*Lennox GS Units 1- 4 Exciter Replacements  
Notification of Approval of Connection Proposal  
CAA ID Number: 2005-EX252*

## **LENNOX GS – EXCITER REPLACEMENT IESO EXPEDITED SYSTEM IMPACT ASSESSMENT – 2005-EX252**

Figure 1. Block Diagram of Excitation System

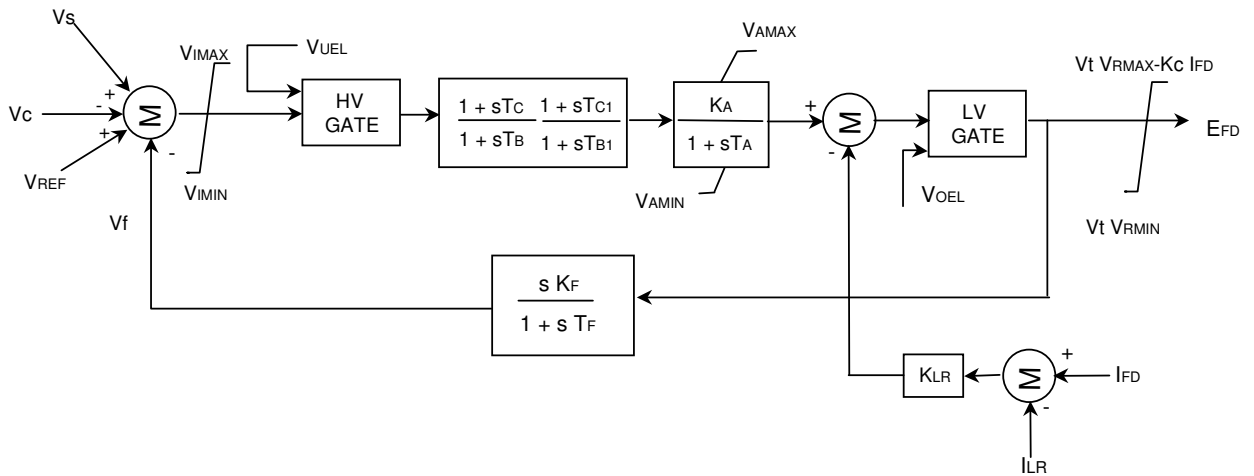
The models and data for the new exciters are the same as those for the existing exciter systems.

The performance of the new exciters not been verified through testing. After the installation of the new exciters, the proponent is required to perform commissioning tests to validate the control models and data. The test results must be supplied to the IESO within three months of in-service date. If the actual data differ materially from the data that was used in the assessment, then the analysis will need to be repeated.

As soon as the commissioning tests are completed and actual data is available, the connection applicant is required to provide an updated block diagram model of the excitation system. Using these data the IMO will perform studies to verify the behaviour of the excitation system and establish the need for any new controls and adjustments, as part of the Facility Registration Process.

**Figure 2. Block Diagram of PSS**

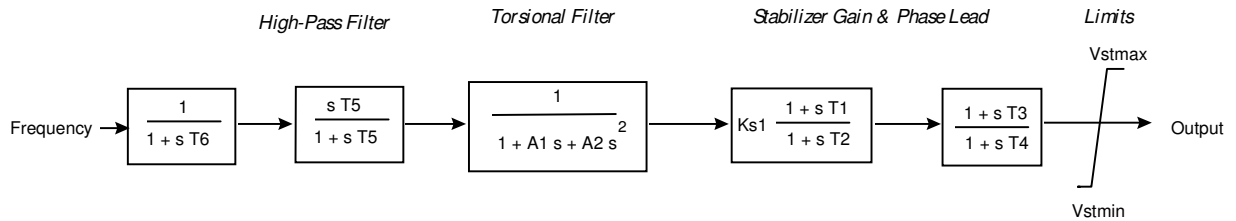
The models and data for the new PSS's are the same as those for the existing stabilizers.

The PSS model and data is to be confirmed by the connection applicants upon the completion of commissioning test and provided the IESO in view of completing the Facility Registration Process.
